UNITARY PLAN UPDATE REQUEST MEMORANDUM

SUBJECT *Alteration to Designation 6773 Glenn Innes to Tamaki Road Shared Path in accordance with s 181(3) of the Resource Management Act*

Notice of requirement for a minor alteration to a designation under section 181(3) of the Resource Management Act 1991

Designation number: Shared Pathway – Glenn Innes to Tamaki - 6773
Requiring authority: New Zealand Transport Agency
Site address: 337 Kohimarama Road, Meadowbank

Figure 1 – Proposed extent of alteration to designation

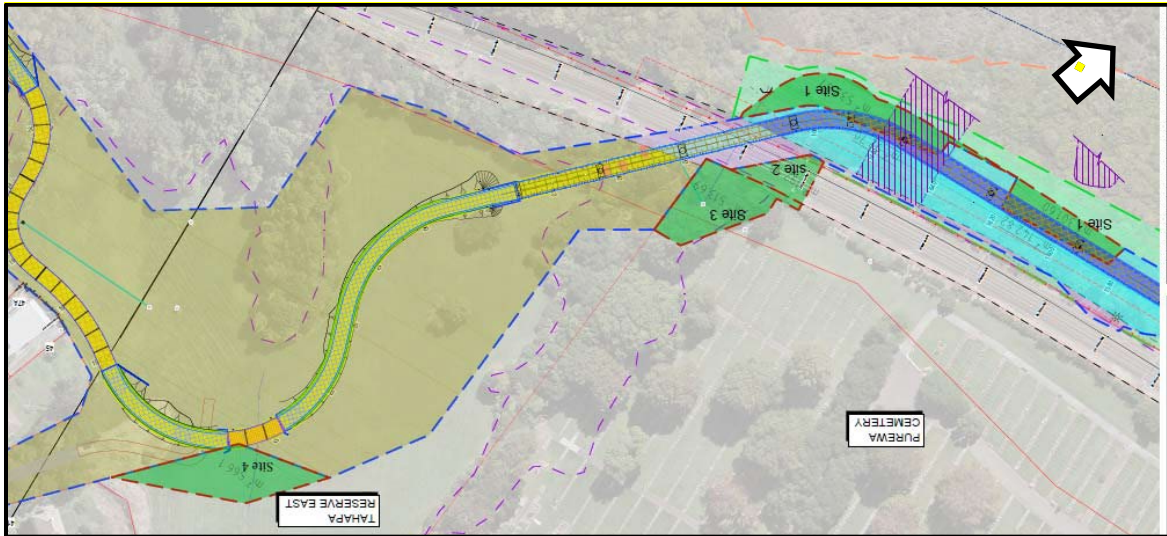
2.3. Following detailed engineering design, the request seeks to expand the designation boundaries in four separate locations as shown in green on **Figure 1** below, to accommodate:

2.4. Due to KiwiRail's requirements to provide for a future third line and to provide for the potential derailment of trains, the span of the shared path overbridge in this location must be increased. This has resulted in a redesign of the path which translates to a change in the angle of approach and in the construction materials to ensure the bridge can support the increased span.

2.6. The original designation had anticipated the installation of a temporary level crossing over the rail tracks to enable personnel to access the various sites during the construction phase. Due to KiwiRail's requirements this access must now be an elevated bridge over the railway. Sites 1, 2 and 3 will include the footings and ramp access for this temporary bridge.

2.7. Due to the redesigned superstructure of the shared path bridge a crane is required to lift the components into place. To enable the appropriate operation of this crane the designation is proposed to be expanded to include Site 3 for the location and operation of the crane

Figure 2 – Volcanic viewshaft and SEA

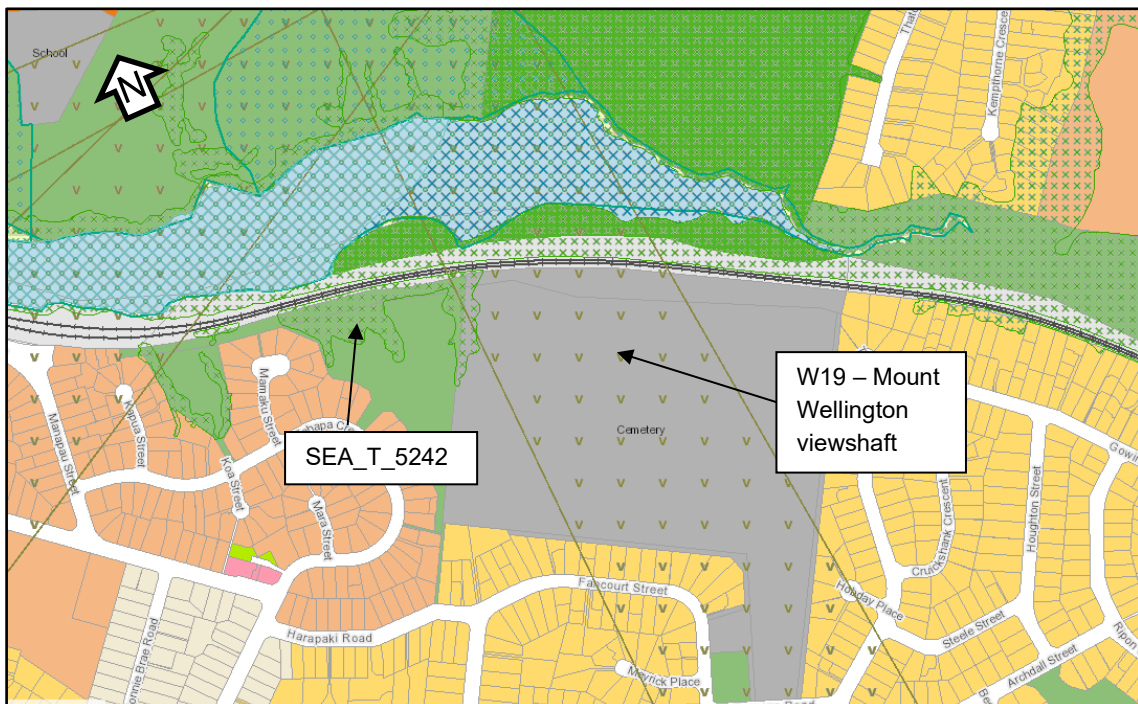
Sites 1 and 3 are located within SEA_T_5242 (refer **Figure 2** below). Sites 1 and 3 are heavily vegetated. None of the sites extend into the Coastal Marine Area nor any marine based SEA in the area.

The area is also subject to a Regionally Significant Volcanic Viewshafts and Height Sensitive Areas Overlay - W19 Mount Wellington (refer the 'v' shape area in **Figure 2** above). The lowest point of the viewshaft is 48m above the land subject to the alteration.

confirmed that the lowest height to intrude the viewshaft is 48m above the ground. Mr Elder confirms that both the temporary pedestrian bridge and the realigned permanent shared path bridge are unlikely to intrude into this viewshaft. Therefore, the activities in Table D14.4.1 and the standards under Chapter 14.6 of the Auckland Unitary Plan (OIP) do not apply.

Attachment 3 –
Updated GIS Viewer for Designation 6773

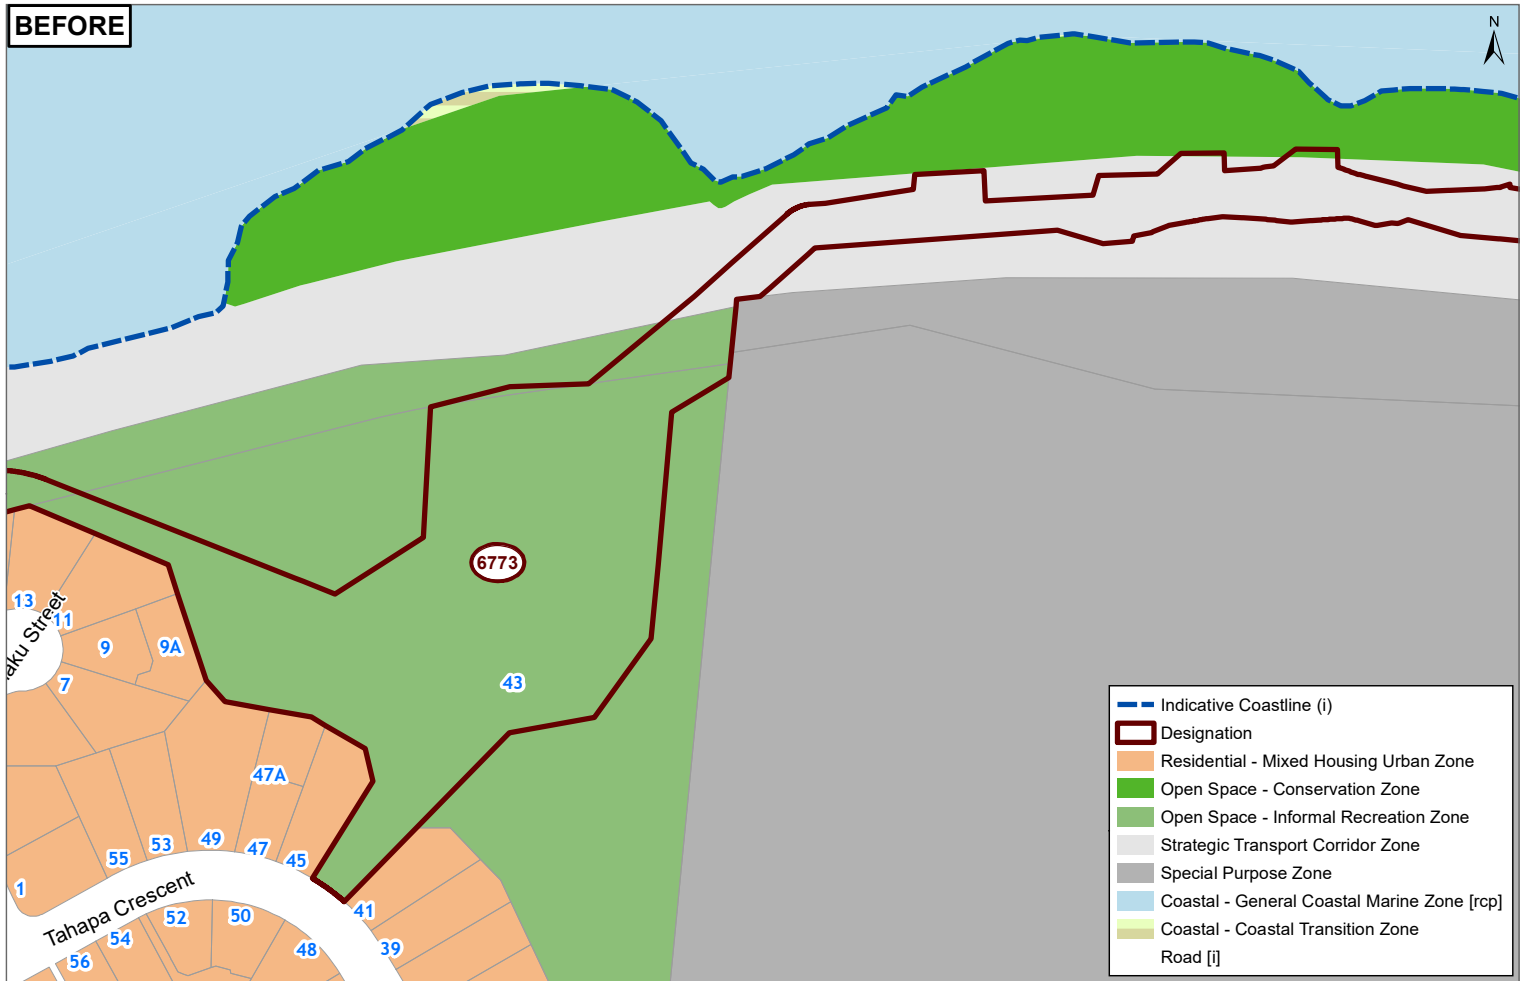
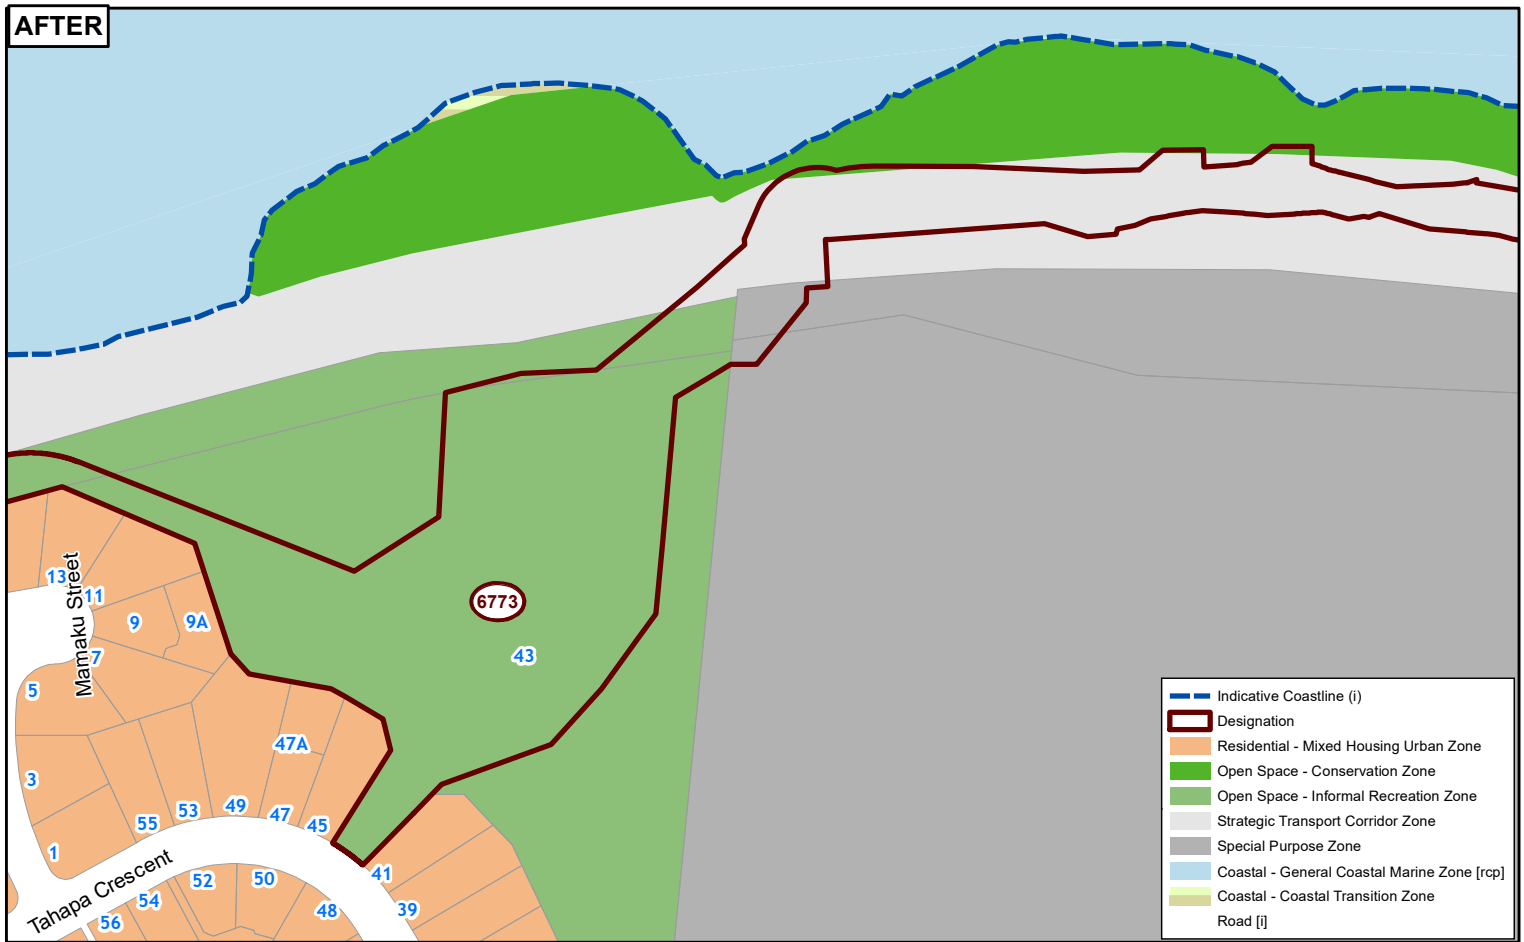
<p>Changes to diagrams</p>	<p>The designation boundaries will be extended to enable the location and operation of temporary construction structures and equipment and for the realigned permanent shared path in this location. Also to enable the restoration works and replanting of the area.</p>
<p>Changes to spatial data</p>	<p>New outline for this section of the designation – as provided</p>
<p>Attachments</p>	<p>Attachment 1 – Auckland Council Section 181 (3) Determination Report</p> <p>Attachment 2 – Updated Text for Designation 6773</p> <p>Attachment 3 – Updated GIS Viewer for Designation 6773</p>
